AGENDA
DANIA BEACH CITY COMMISSION
REGULAR MEETING
TUESDAY, FEBRUARY 26, 2019 - 7:00 PM

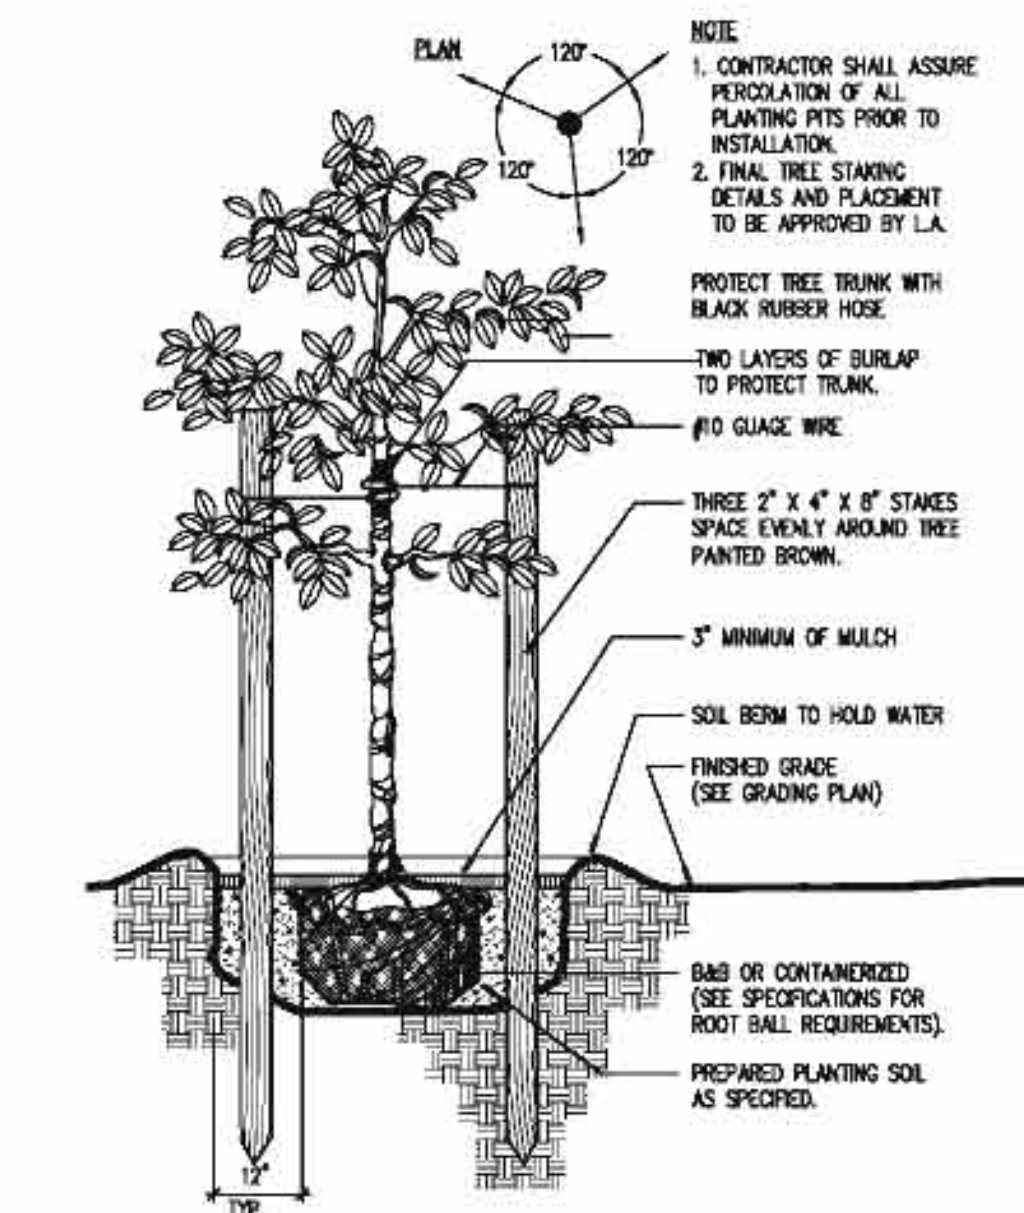
2) On sheet L-03, in the landscape calculation table, the provided Total Plant Material quantity does not match the provided material quantity in Sec. 275-190 section.

Response: Corrected. See revised sheet L-03
